ALERT SERVICE BULLETIN

429-15-16

MODEL AFFECTED: 429

SUBJECT: TAIL ROTOR PITCH LINK BEARING, INSPECTION AND UPGRADE OF.

Figure 1 – Tail Rotor Pitch Link Bearing Liner

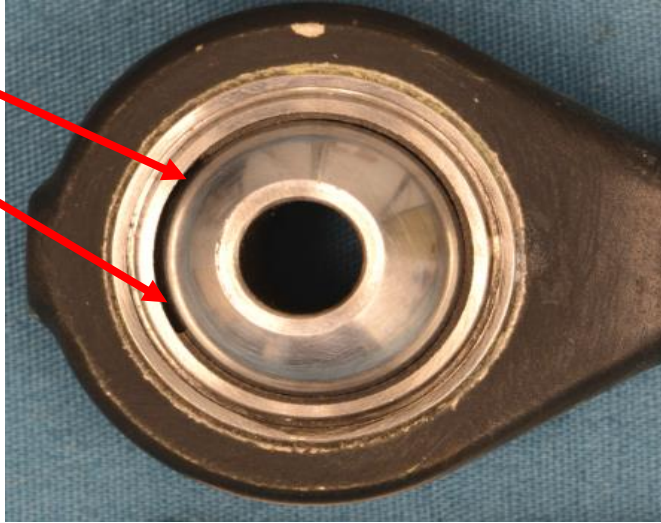
2. Verify the part number of the tail rotor pitch link assemblies to determine if affected by **Part II** of this bulletin.
 - a. If affected, make sure compliance to **Part II** of this bulletin is accomplished within the allowable compliance period.
3. Remove the tail rotor pitch link assemblies from all four locations (DMC-429-A-67-20-00-13A-520A-A).
4. Perform a dimensional check of both axial and radial play (DMC-429-A-67-20-00-11A-310A-A). With a 10X magnifying glass, visually inspect the bearing liner condition for cracks or deterioration of the liner or if the liner extrudes out of the plane (Figure 1).
 - a. Replace any bearing that exceeds the allowable limits and/or if cracks or deterioration of the bearing liner are noted.

Missing Liner

Bearing Liner Extruding

- i. Perform **Part II** of this ASB or replace the affected tail rotor pitch link assembly with an acceptable part.
 - ii. If **Part II** has already been accomplished on the affected tail rotor pitch link assembly, replace the bearing per the instructions in the 429 Maintenance Manual (DMC-429-A-67-20-00-11A-600A-A) or replace the tail rotor pitch link assembly with an acceptable part.
5. Inspect the tail rotor pitch link assembly sealant (C-251) for condition.
 - a. Make sure there are no pin holes or voids present in the sealant.
 - b. The thickness of the sealant should not exceed 0.025 inch (0.64 mm), should extend over the roll staked lip by a minimum of 0.030 inch (0.76 mm), and remain clear of the bearing ball.
